SUBJECT: Response to Questions Regarding HEU/LEU Conversion at Manhattan College
(your letter of July 10, 1989)

**MANHATTAN COLLEGE ZERO POWER REACTOR
QUESTIONS AND ANSWERS**

Figure 1. Power Distributions and Power Peaking Factors

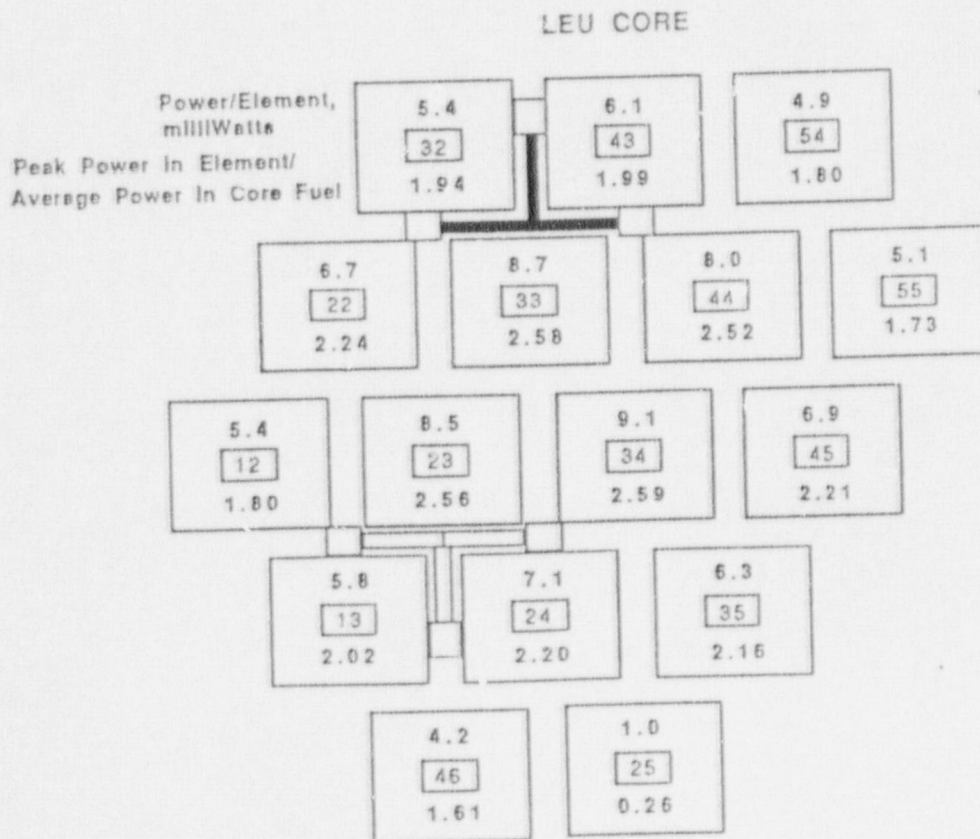
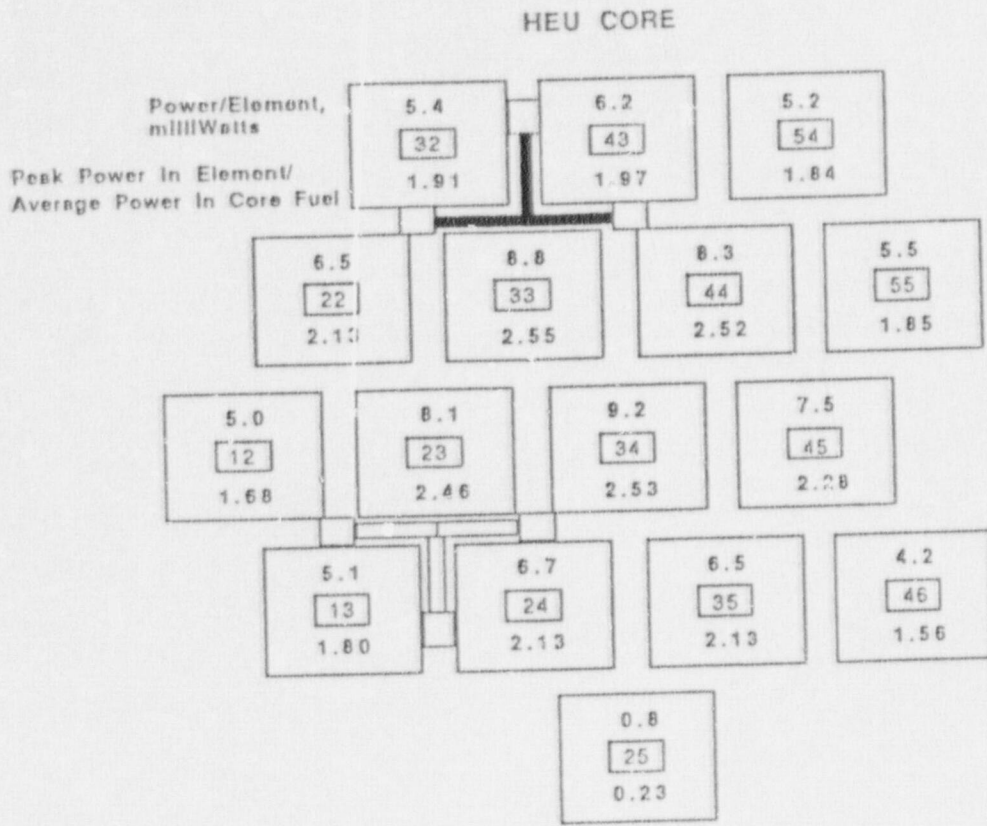
- (4) Q Please provide any HEU versus LEU comparisons of power distributions in the fuel elements, and any power distribution versus fuel loading information in the partially loaded element.

- A The power distribution and nuclear power peaking factors that were calculated by the ANL for the existing HEU core and the LEU reference core with the shim and regulating rods fully-withdrawn are shown in Figure 1. ^(a) The power distributions show the power per fuel element (in milliwatts) and the power peaking factors show the absolute peak power density in each fuel element (computed at the edge of the mesh interval with the highest power) divided by the average power density in the core fuel.

- The data in Figure 1 shows that the power distributions and total power peaking factors are nearly the same in the HEU and LEU cores. However, the limiting fuel element in the HEU core is located in grid position 33 and the limiting fuel element in the LEU core is located in grid position 34. This is because the location of one fuel element was changed in the LEU core (from position 46 to position 14) to increase the reactivity worth of the regulating rod.
